October 28, 2009

**Re: Comments on Final EIS for the Mandan, Hidatsa and Arikara (MHA) Nation  
Proposed Clean Fuels Refinery Project**

Thank you for this opportunity to comment on the Final Environmental Impact Statement (FEIS) for the proposed new MHA Nations Clean Fuels Refinery (“the Project”). Because of my engineering background and experience over the last 20 years analyzing oil industry emissions and environmental impacts,<sup>1</sup> I have been asked by members of the MHA Nations and by the Environmental Integrity Project to review and comment on the FEIS. I also submitted comments on August 29, 2006 regarding the Draft EIS for the Project. As I will discuss below, the FEIS does not adequately address the concerns raised in the August 29, 2006 comments. Those comments are attached to this document and fully incorporated herein. The August 29, 2006 comments include information and data that have not been adequately addressed by the FEIS and continue to be a basis for the concerns raised in these comments.<sup>2</sup>

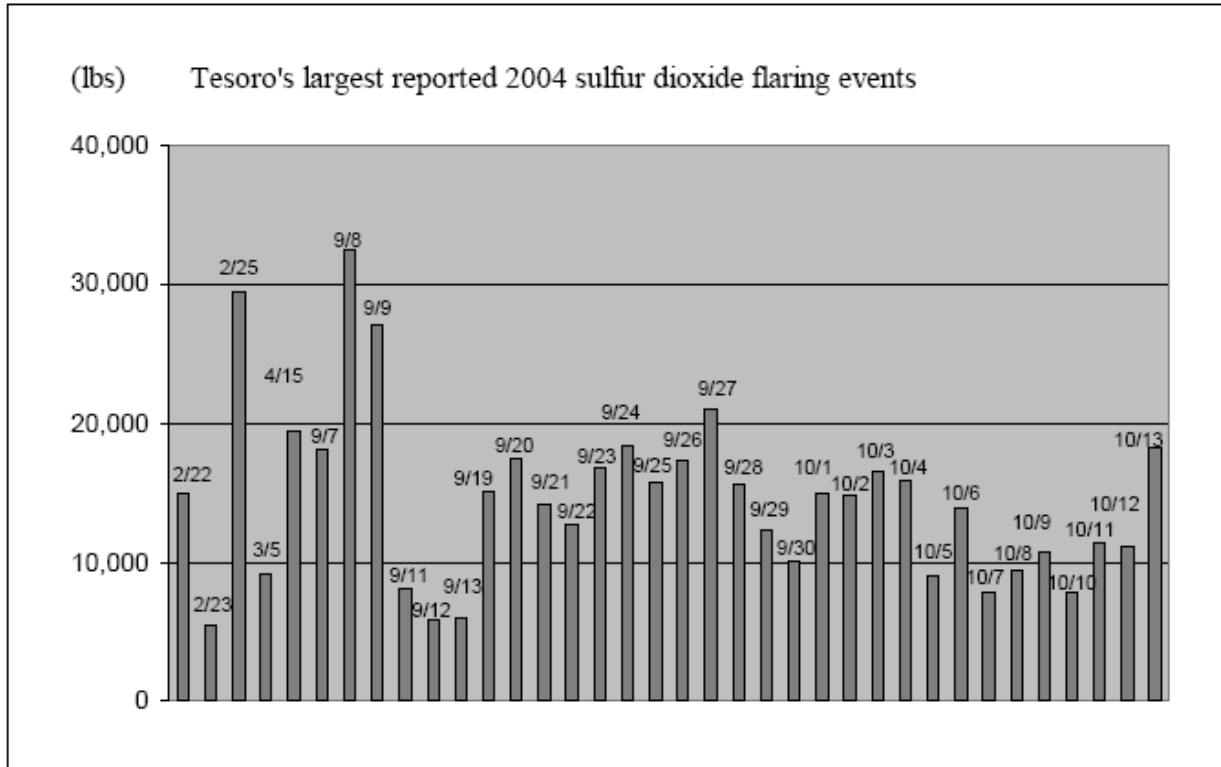
Another refinery which the BAAQMD evaluated had much higher flaring, frequently exceeding 10 tons. (Again, from BAAQMD online data.<sup>9</sup>) In 2004, the Tesoro Martinez refinery (Avon) had 36 flaring events that generated more than 5,000 lbs. of sulfur dioxide each, with the maximum event in one day over 30,000 lbs (15 tons). This was after a drastic reduction in flaring at the refinery, when flaring had been continuous (causing many tons per day of both SO<sub>x</sub> and VOC emissions, due to a lack of sufficient compressor capacity). After the refinery

purchased two new large compressors, the emissions went down from continuous flaring of dozens of tons every day, to the still high level of 36 flaring events greater than 2.5 tons. Later, after the BAAQMD adopted a flare control regulation requiring a flare minimization plan, flaring reduced further. Here is a chart of the flaring events in 2004 at Tesoro:

Both ConocoPhillips and Tesoro (in the 100,000 barrel per day range) are larger than the MHA Nation refinery, proposed at 10,000 barrels per day. However, individual flaring events at the MHA Nation refinery could easily exceed many tons in one day. Without an analysis and requirements providing sufficient compressor and gas recovery capacity, without any Flare Minimization Plan, without any permit limit on sulfur content in incoming crude oil (that greatly affects sulfur dioxide emissions during flaring), without permit requirements for root cause analysis following flaring events in order to ensure that the same cause is not repeated, the MHA Nation refinery could easily exceed 50 tons per year in SOx emissions from flaring, which in addition to the 51 tons estimated in the FEIS, would trip the PSD threshold for SOx.
